Additions and Renovations
Platt Technical High School
Milford, CT

ADDENDUM NO. 6

August 21, 2019

RA6-02

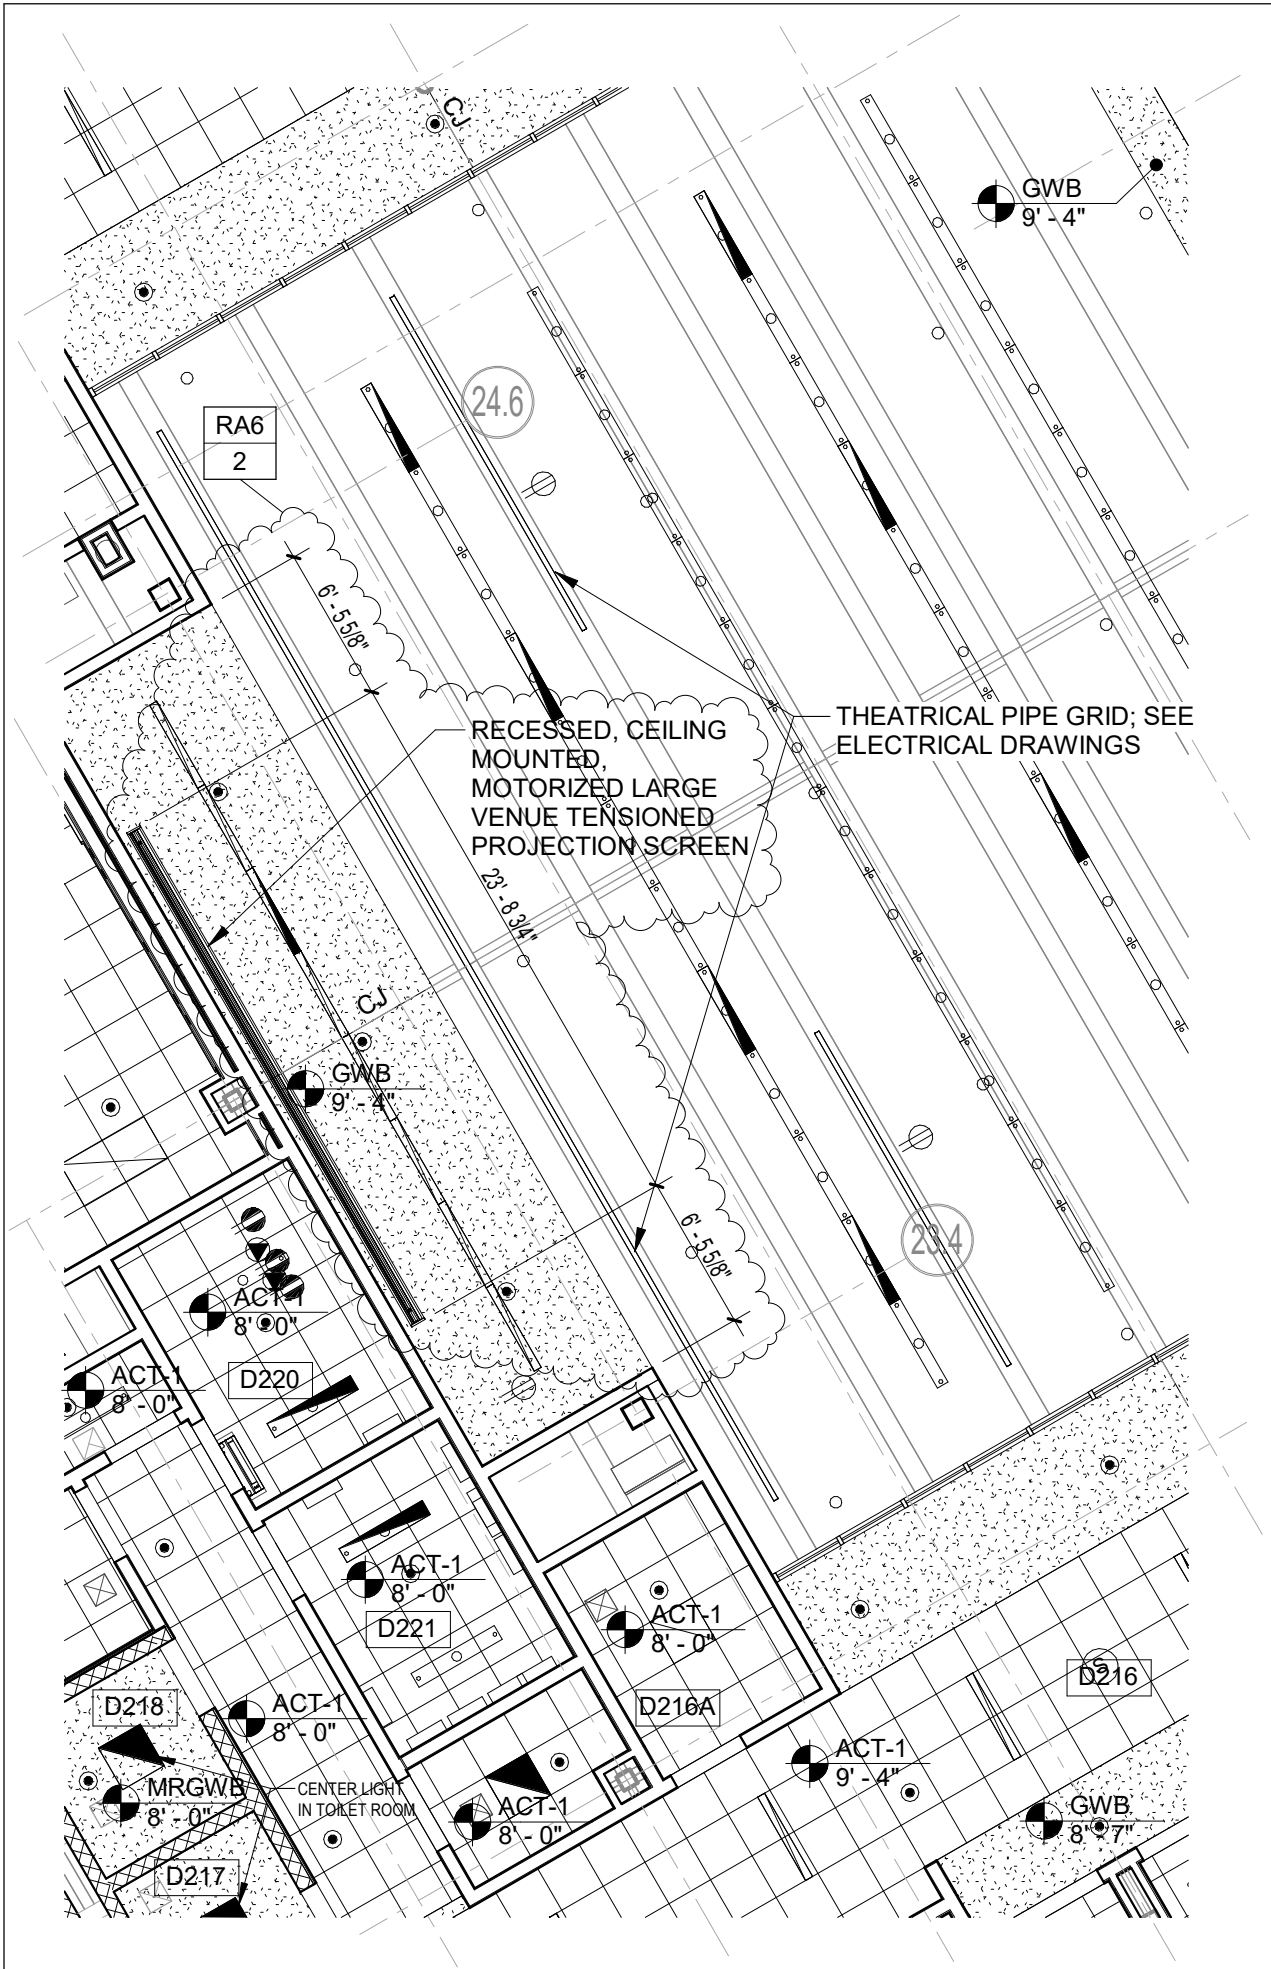
- ADD 6-026 DRAWING A8-1-2D – SECOND FLOOR REFLECTED CEILING PLAN – AREA D**
RELOCATED wall mounted Motorized Projection Screen to a recessed, ceiling mounted, Motorized Large Venue Tensioned Projection Screen per Sketch RA6-02.

RA6-03

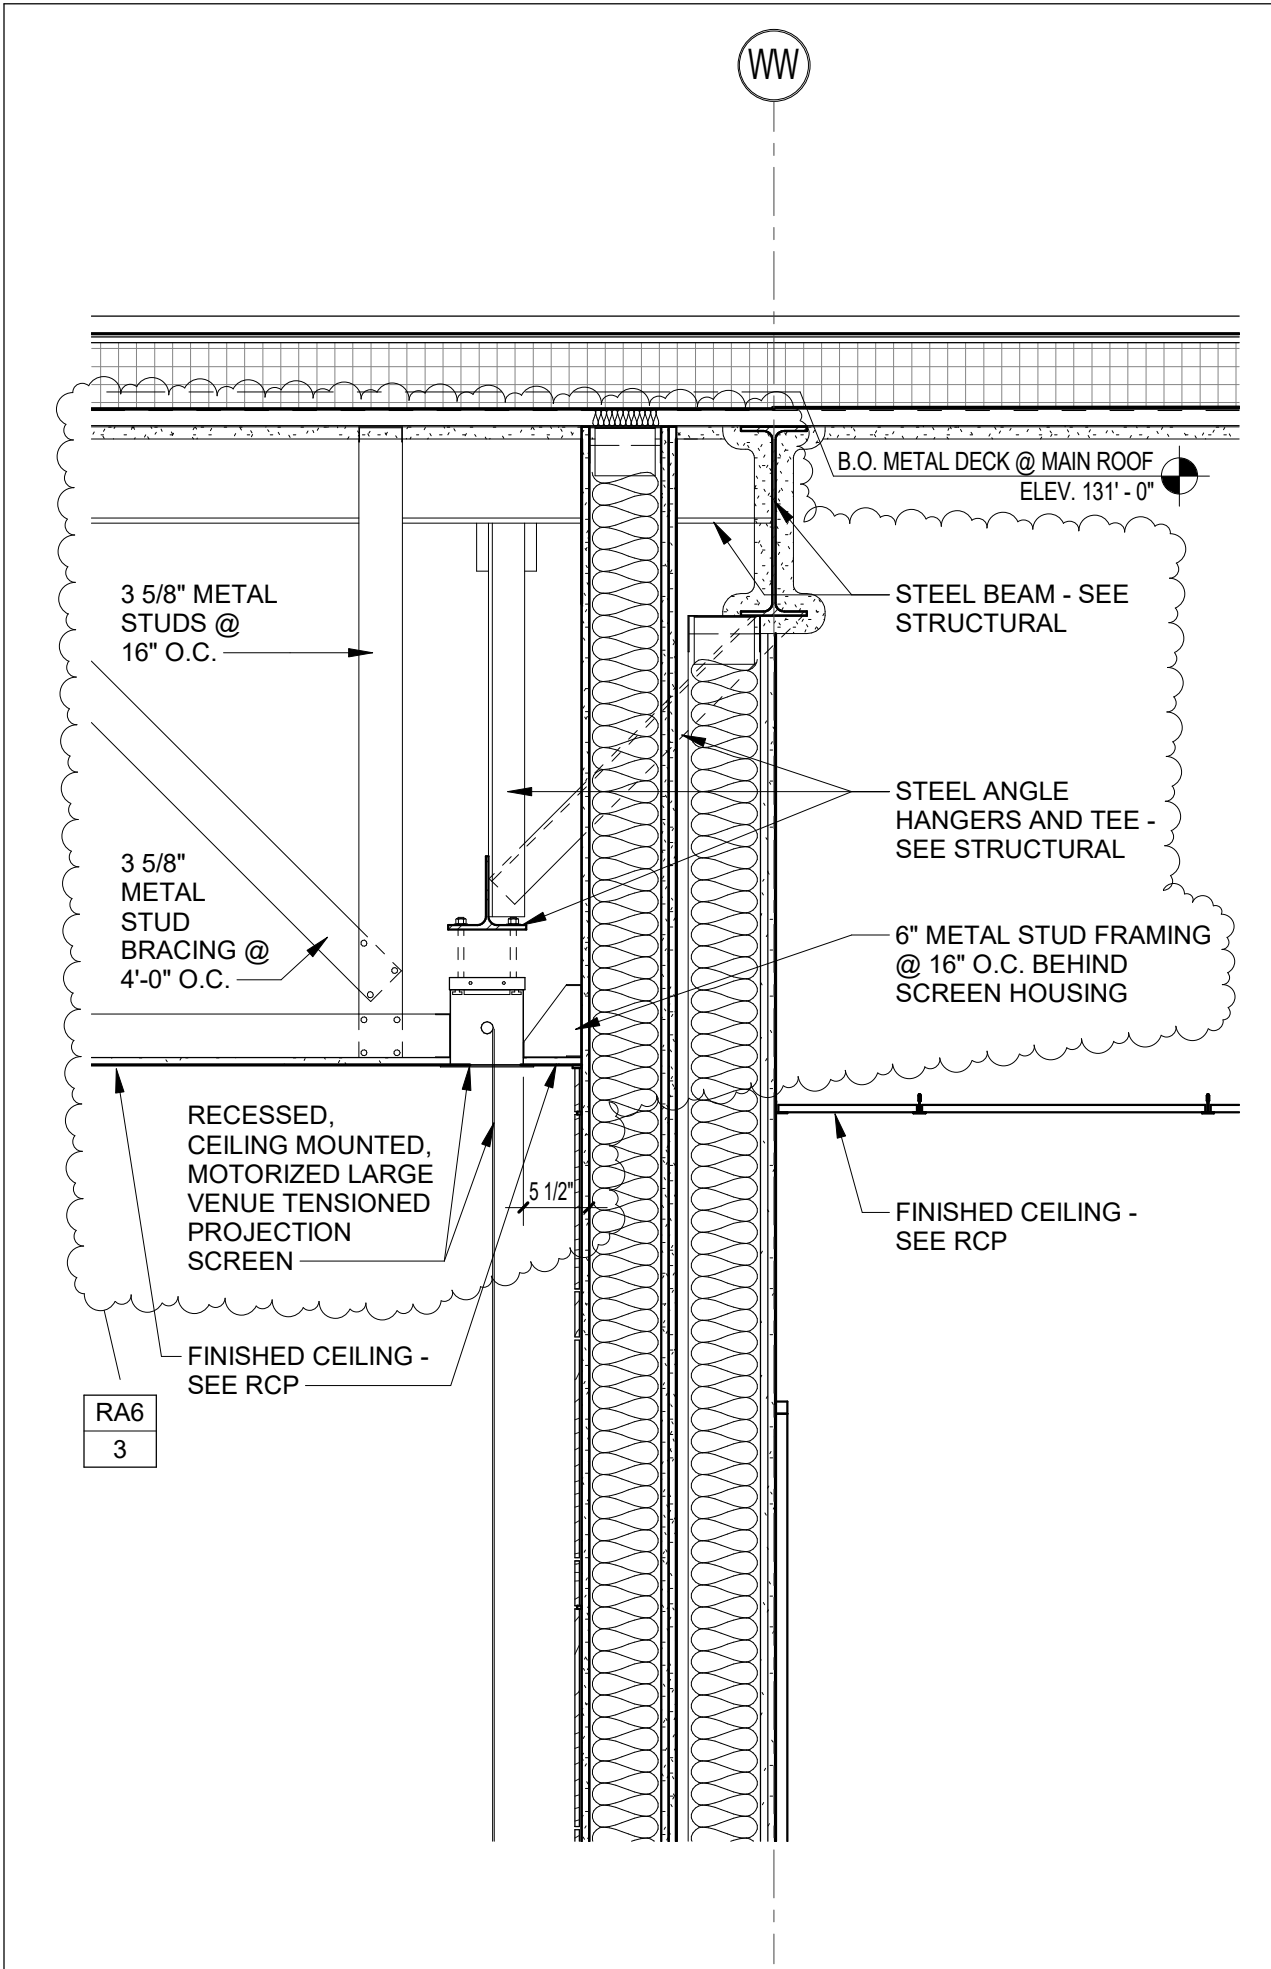
- ADD 6-021 DRAWING A3-2-15 – WALL SECTIONS**
Wall Section 1: ADDED detailing for recessed, ceiling mounted, Motorized Large Venue Tensioned Projection Screen per Sketch RA6-03.

RA6-04

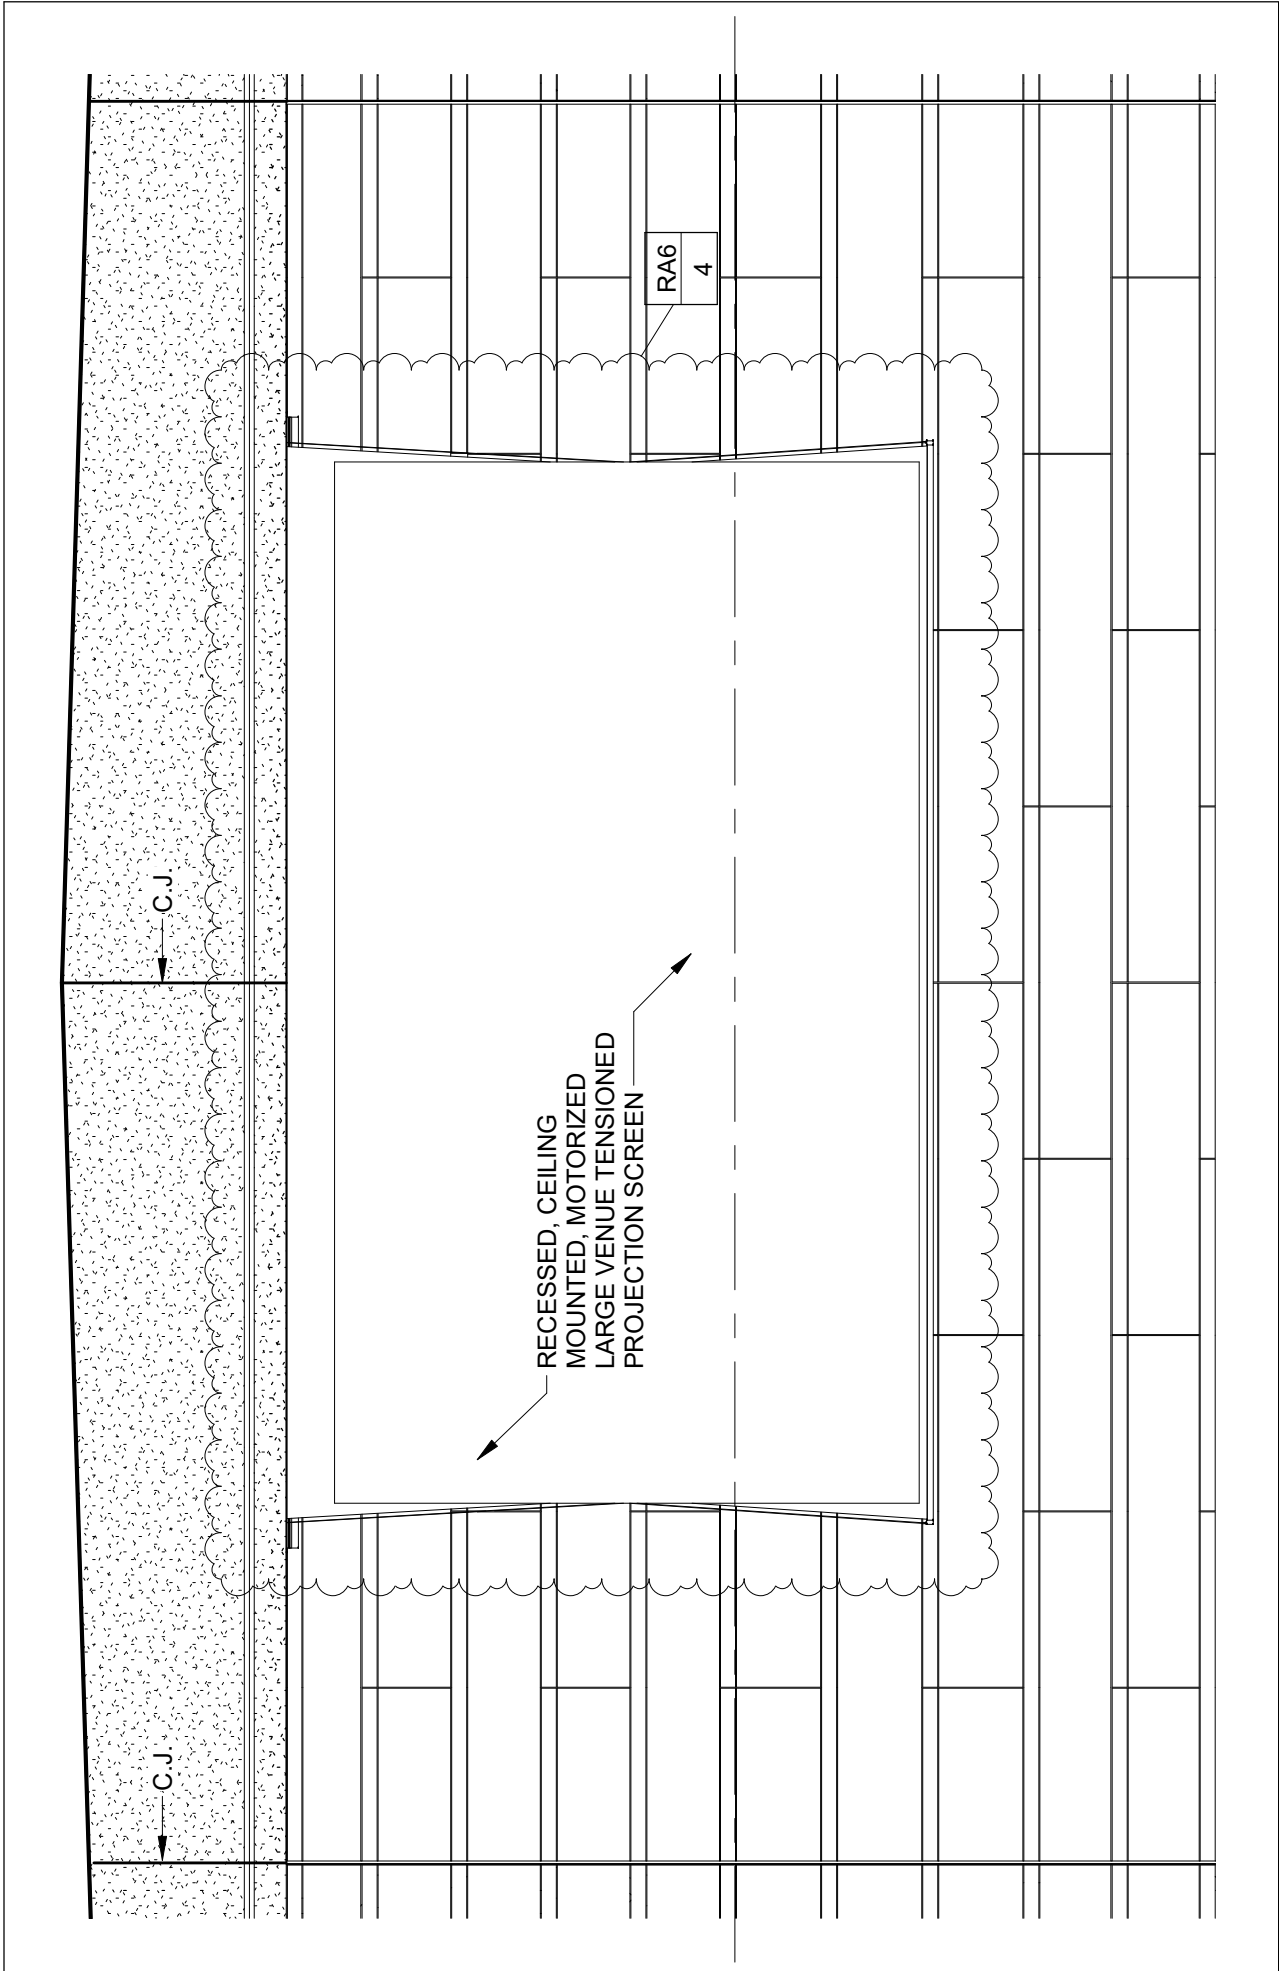
- ADD 6-019 DRAWING A1-1-2C – SECOND FLOOR PLAN – AREA C**
Room C221: ADD “Similar” Interior Wall Section Tag 3/A2-2-9 to the East Wall.
- ADD 6-020 DRAWING A2-2-11 – INTERIOR ELEVATIONS**
Interior Elevation 1: REVISE note and graphics regarding Motorized Projection Screen per Sketch RA6-04.

RA6-05

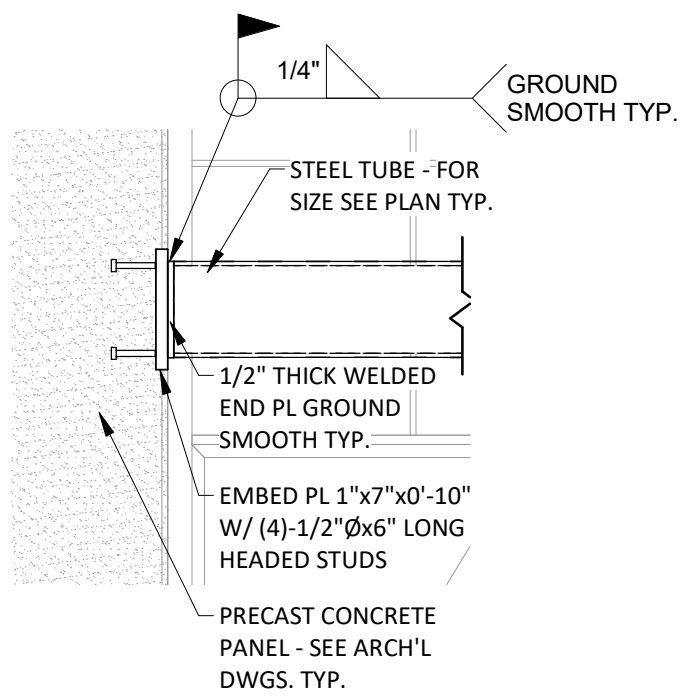
- ADD 6-025 DRAWING A6-3-21 – CURTAIN WALL DETAILS** (Drawing added to the set in Addendum No.3)
Detail 6: ADD Detail 6, Typical Sunshade Detail, per Sketch RA6-05.

R8

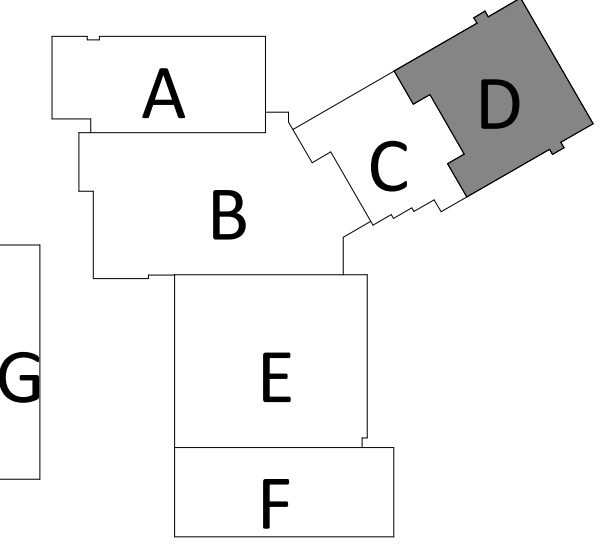
- ADD 6-027 DRAWING S1-1-2 – SECOND FLOOR FRAMING PLAN – OVERALL**
REVISE concrete strength for slabs “S-1” and “S-2” to be 4,000 PSI in the Concrete Slab Table.
- ADD 6-028 DRAWING S1-1-3D – ROOF FRAMING PLAN – AREA D**
ADD Supports for projector screen per Revision RS6-3.
- ADD 6-029 DRAWING S2-3-1 – PRECAST WALL ELEVATIONS**
ADD “Typical Exterior Wall Girt Elevation – Area E and Area F” per Revision RS6-1.
- ADD 6-030 DRAWING S4-2-21– STRUCTURAL SECTIONS**
ADD sections “S12” – refer to Sketch RS6-001.
- ADD 6-031 DRAWING S5-1-1 – STRUCTURAL SECTIONS ROOF**
ADD Section “R8” – refer to Sketch RS6-002.
